Mike Griew, 19TH July 2017

I wish to comment on points concerning helicopter safety raised in reports submitted by Graham Liddy and DBS Consultation/Jensen Marks Aviation Consultants pertaining to submissions made to An Bord Pleanála by the Department of Defence/Irish Air Corps. Having read these reports, and after consulting with expert colleagues and drawing on personal knowledge of twin-engine helicopter operations gained from 21 years and approximately 7200 hours experience operating medium-sized helicopters in the offshore oil and gas industry:

Flight through dangerous sections of the Indaver plume

Fig. 1

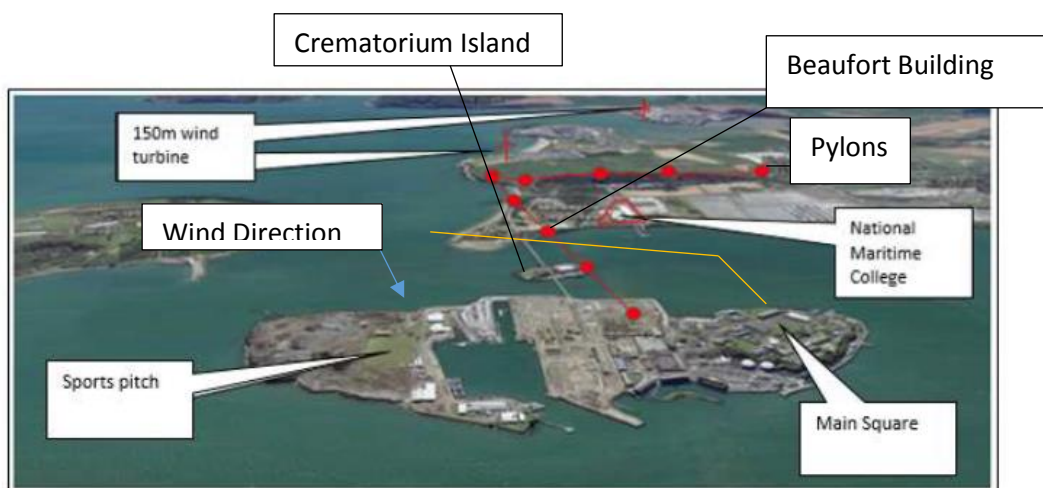
The aerial photograph on page 29 of the DBS/JM report, shown below with noteworthy captions (the UCC Beaufort Building, Electricity Pylons, Crematorium Island) added, sets the scene.

- A fully laden AW139.
- Wind speed 10kts, consistent with the sea state indicated in Figure 6, blowing from a southerly direction.
- A distance of 1.2km (rounded up to 0.7nm for convenience) from the main square to the Indaver site.
- Engine failure occurring just after take-off decision point (TDP) as depicted in Appendix H of the Liddy report, at a height of 180ft above ground level (from Liddy's description of a Cat. A helipad take-off profile in 7.2.2.2).

Fig 2. Viewpoint from TDP (Approx. 150ft agl.)

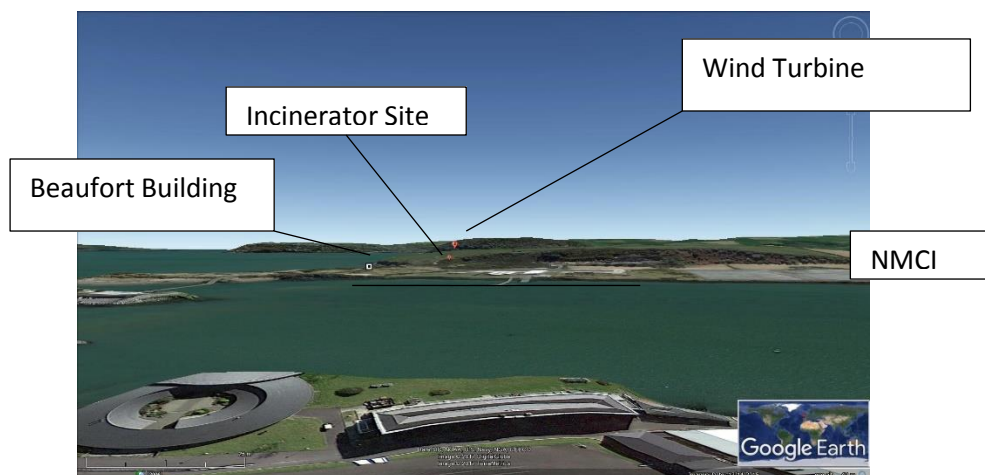
Half way across the channel, however, I conjecture that dealing with approaching obstructions would override any other considerations, and the pilot would face three choices:

- 1) Fly straight ahead, attempting to climb over the NMCI buildings or the Hammond plant, on a path taking him/her initially towards rising ground and the DePuy wind turbine, then towards factories and another wind turbine in the distance;
- 2) Deviate right, turning towards Ringaskiddy villiage, rising ground and factories in the distance, or the Port of Cork dockyards;
- 3) Deviate left, turning towards Spike Island and open water, a path that would take him/her over pylons and pass close to the Beaufort building, but expedite flight to a clear, unobstructed area beyond.

The following Google Earth Images simulate the pilot's view. These are marred by lack of the elevation detail needed to recreate realistic scenes, however they are instructive.

Fig. 4. Viewpoint looking left towards the harbour, from 110m agl.

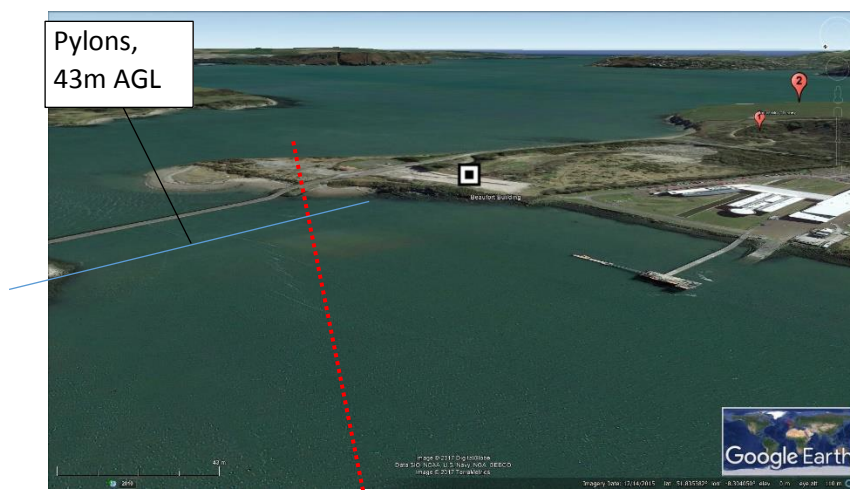
Neither scene presents an obstacle-free view, however in my opinion both tracks are viable, given that the helicopter will be climbing strongly, and both comply with the six degree safety cone described by Liddy and shown graphically in Appendix P. The easterly option would be the natural choice to take, however, if the pilot felt compelled to avoid overflying buildings, factories or the dockyard, for example when carrying an external load. In this case, proximity to the Beaufort building and overflight of the pylons, which would be cleared by at least 250ft, would be a reasonable price to pay for an expeditious path to an open area.

Fig. 7

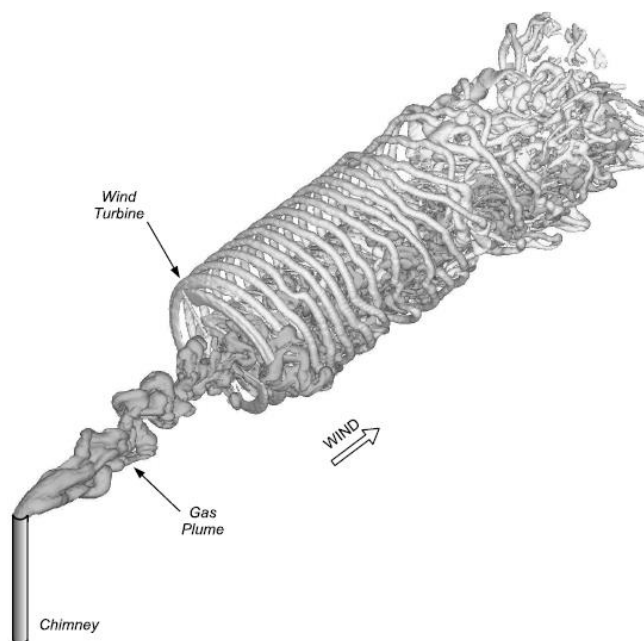
Although the DePuy wind turbine would be upwind of the incinerator chimney in the scenario being described, the converse of the arrangement shown in figure 7, I find it equally plausible that emissions from a chimney downwind of the turbine would be sucked into the stream, given that the top of the chimney, which is 265ft above sea level would inject the plume directly into the path of the vortex which would extend from 240ft to 570ft amsl. (according to DBS/CM in section 9.11, the turbine blade tip height is 173m, the blade radius is 50m according to Liddy in section 5.9.1., and in this section the chimney height is given as 80m amsl.)

In this scenario, the helicopter will be climbing through 400ft when it enters the vortex stream at a shallow angle, getting ever close to the source of emissions and being exposed to ever-increasing concentrations of whatever gas mixture lies with, as it flies through the stream.

Fig. 8 Plume vertical extent under calm conditions and with wind (From MITRE Corporation report “Expanded model for determining the effects of vertical plumes on aviation safety”, MP120461, Sept 2012)

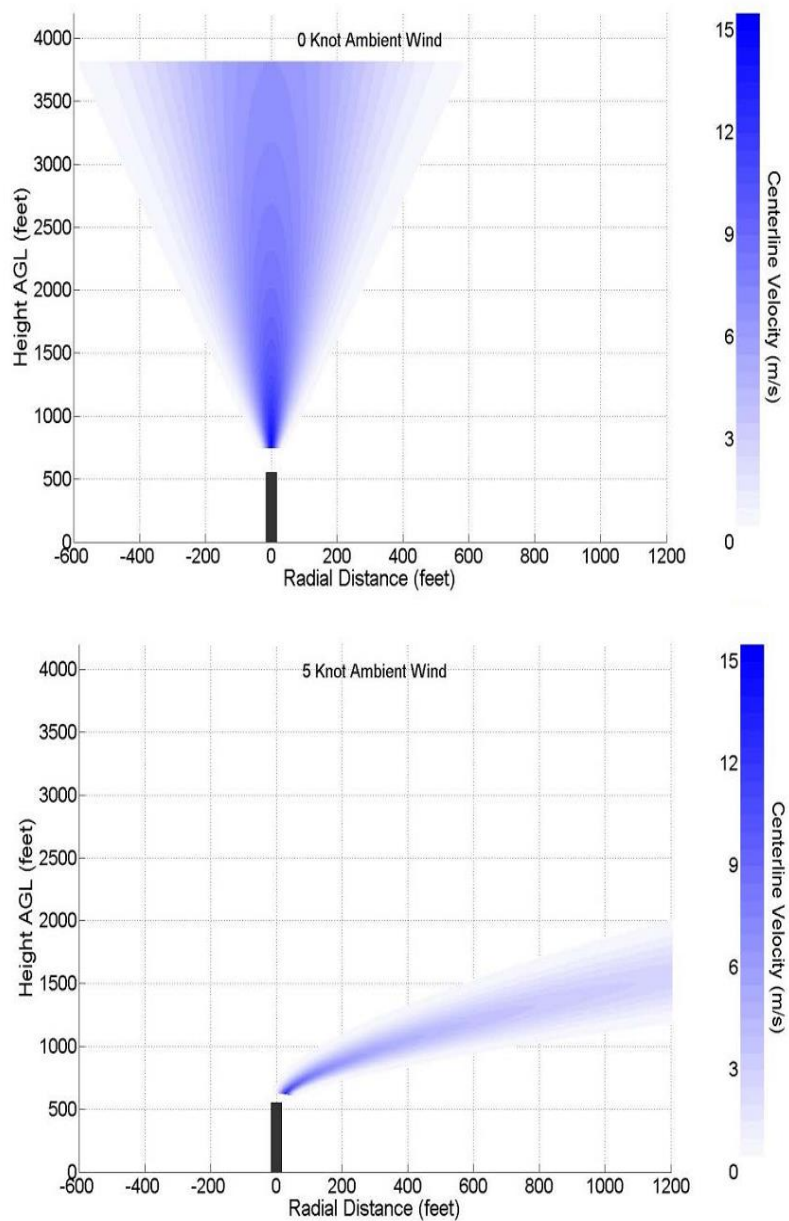
These statements are misinterpretations of Dr Porter’s report (document 07 of the Further Information). As can be seen in Figure 1 of that report, Dr Porter used a *horizontal* grid in his modelling (at an unstated height) and thus the information given in his report concerns only the *lateral* spread of the plume. Dr Porter’s report submitted with the Further Information gives absolutely no indication of the *vertical* extent of the plume.

as the basis for his methodology. Fig. 1 is derived from this report, and shows the vertical extent of the plume as being much greater than its horizontal extent in calm conditions. It is unfortunate that Dr Porter’s report in the Indaver further information, which cites the MITRE report extensively, does not make this fact clear and is in fact silent on the matter of the vertical extent of the plume or its associated danger zone (the relevant diagram from that report is shown below).

Fig. 8

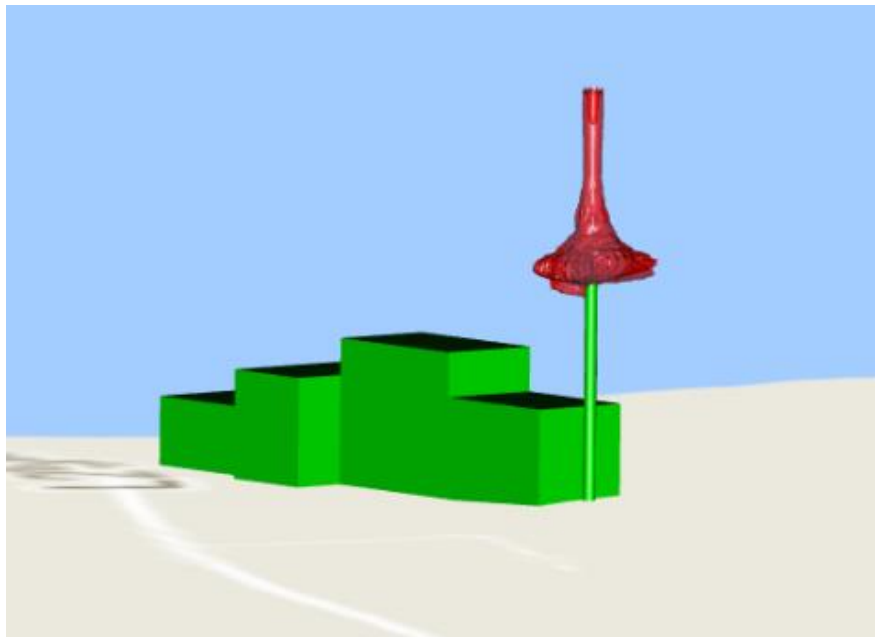
The following screenshot, which shows the Indaver chimney and buildings to scale, gives an example of the output of this modelling. An animation of this model can be found at:

Based on the above calculation of the site-specific risk height for elevated temperature (430 feet), when added to the standard obstacle clearance height of 500 feet, gives a minimum safe height above the stack of 930 feet. The Department of Defence's conclusion mentioned above (1000 ft avoidance zone) thus appears entirely reasonable.
